**Proposal #2: 1002-01-71, WISC 2017 500
C of Madison
Milwaukee Street Bridge B-13-0131
IH 39
Dane County**

This is Addendum No. 01, which provides for the following:

Addendum No. 01
 ID 1002-01-71
 Revised Sheet 94
 November 9, 2017

GENERAL NOTES & QUANTITIES

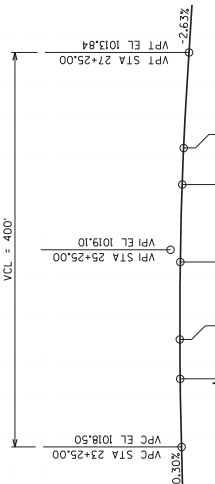
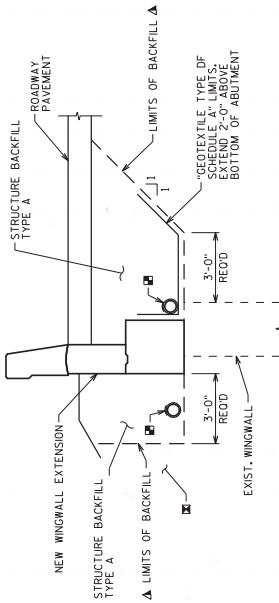
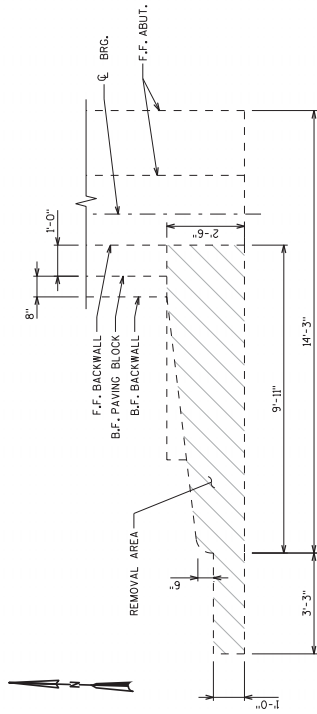
Revised Plan Sheets	
Plan Sheet	Plan Sheet Title (brief description of changes to sheet)
94	Structure 3 of 14 - General Notes & Quantities (updated quantities for three items)
95	Structure 4 of 14 – Wingwall Replacement Details (1 of 2) (updated Outside Elevation View of New Wingwall for Paving Block)
96	Structure 5 of 14 - Wingwall Replacement Details (2 of 2) (updated details and Bill of Bars for Paving Block)
98	Structure 7 of 14 – Superstructure Plan (additional haunch reinforcement added to details)
99	Structure 8 of 14 – Superstructure Details (Hat Bar Layout detail added and Bill of Bars updated)
101	Structure 10 of 14 – Compression Seal Details (updated Proposed Section at Abutment for Paving Notch)

NO.	DATE	REVISION	BY
②	11/7/17	PAVING BLOCK	MSS
①	11/3/17	ADDED HAUNCH HAT BARS	MSS

WINGWALL REPLACEMENT
DETAILS (1 OF 2)
95

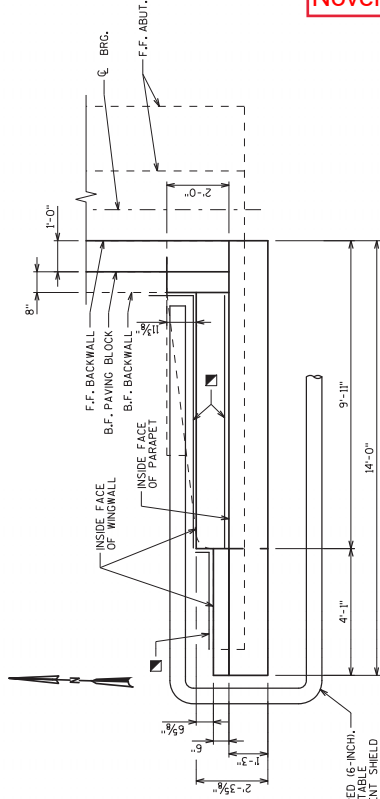
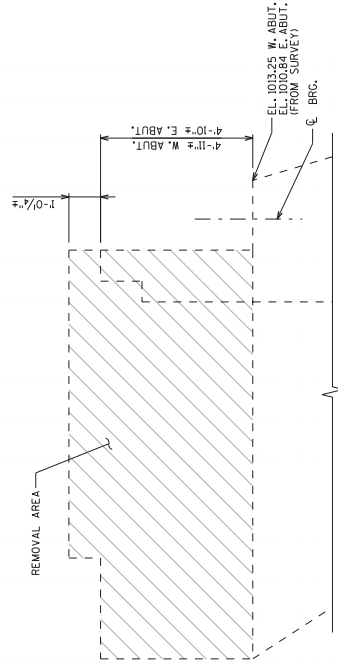
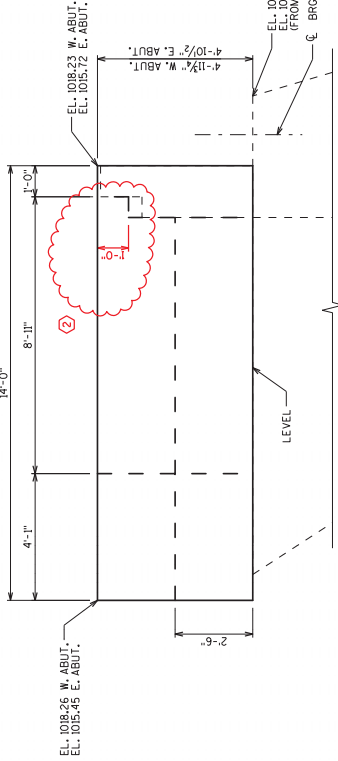
NO.	DATE	REVISION	BY
2	11/7/17	PAVING BLOCK	MSS

SUPERSTRUCTURE PLAN
SHEET 7 OF 14
98

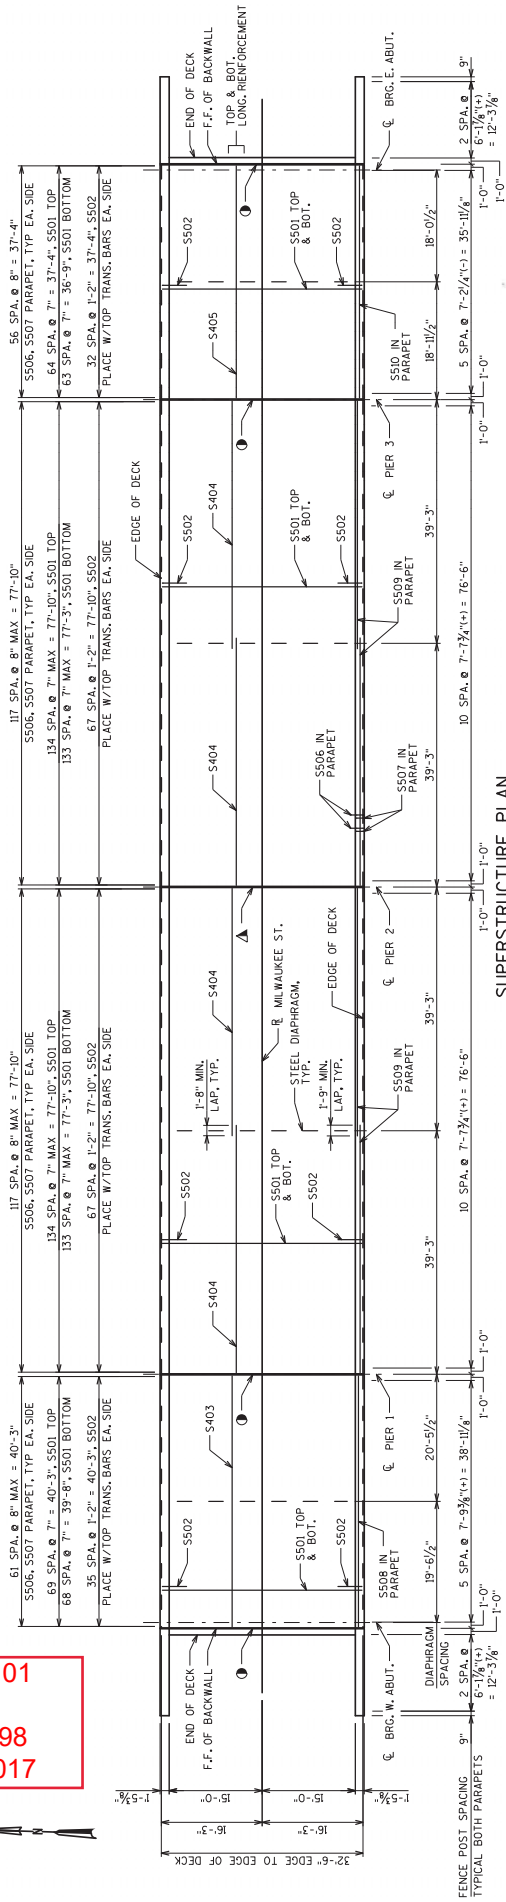
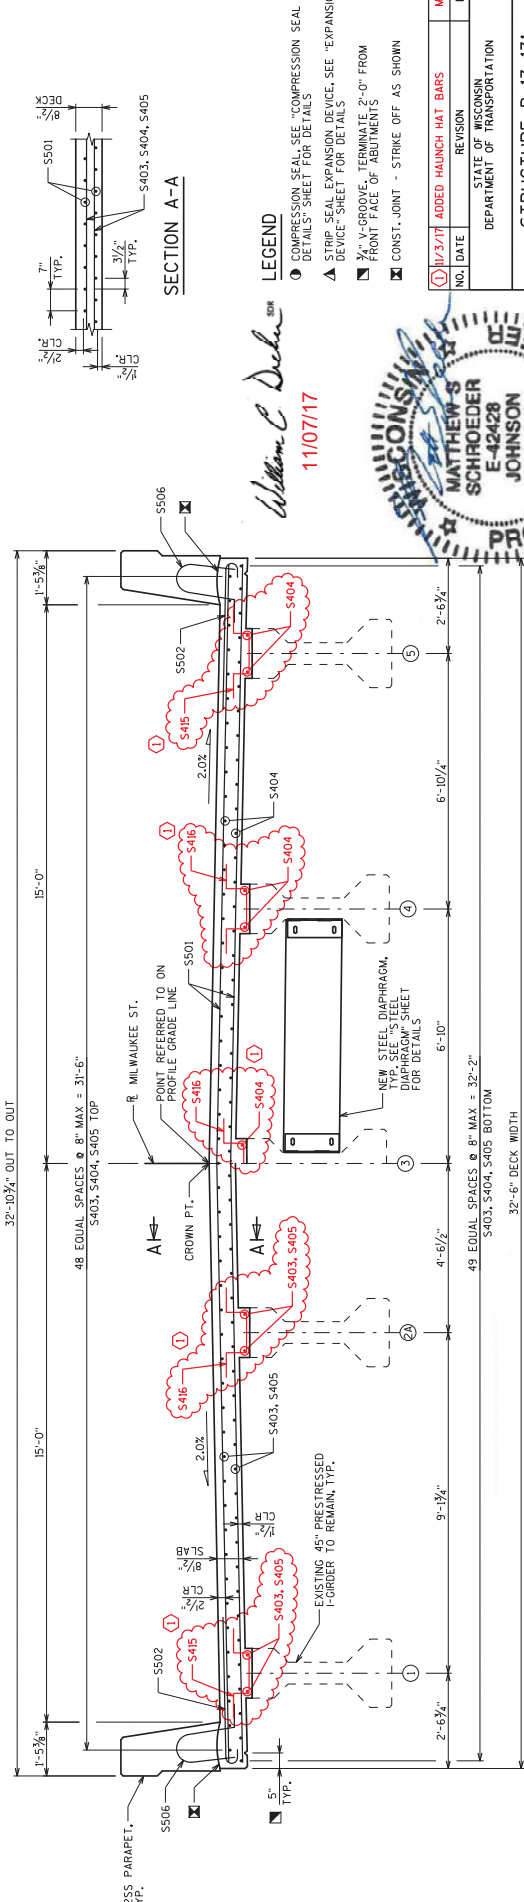
NO.	DATE	REVISION	BY
1	11/27/17	ADDED HAUNCH HAT BARS	MSS

SUPERSTRUCTURE
DETAILS

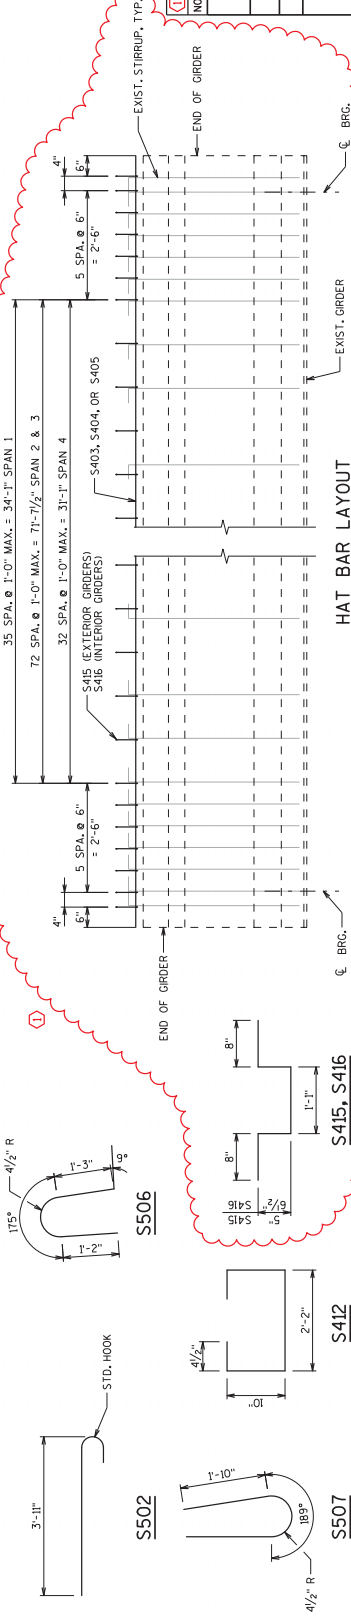
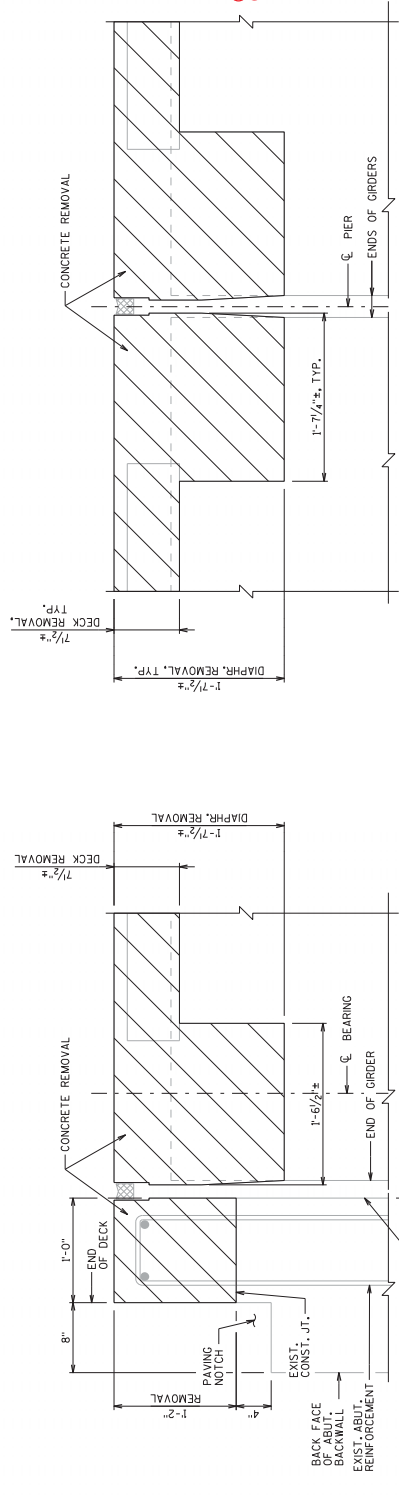
NO.	DATE	REVISION	BY
1	11/27/17	ADDED HAUNCH HAT BARS	MSS

STATE OF WISCONSIN DEPARTMENT OF TRANSPORTATION	
STRUCTURE B-13-131	DESIGNER MSS
COMPRESSION SEAL DETAILS	SHEET 10 OF 14
101

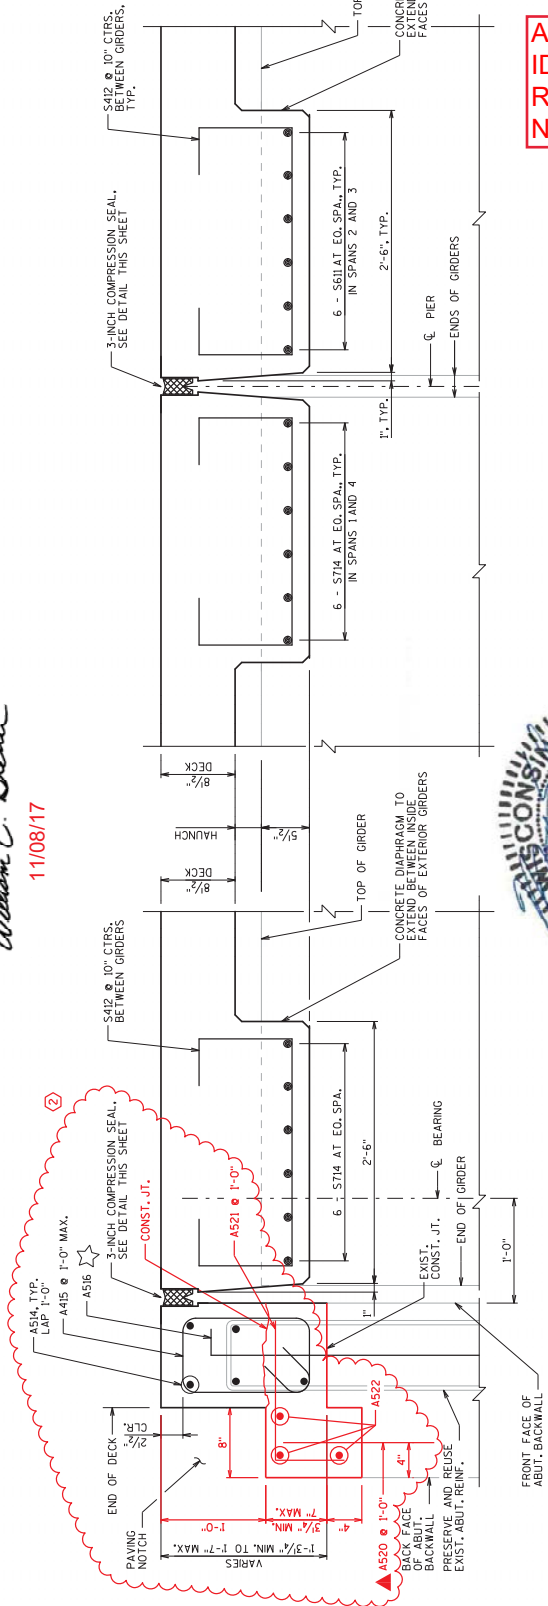
NO.	DATE	REVISION	BY
②	11/7/17	PAVING NOTCH	MSS
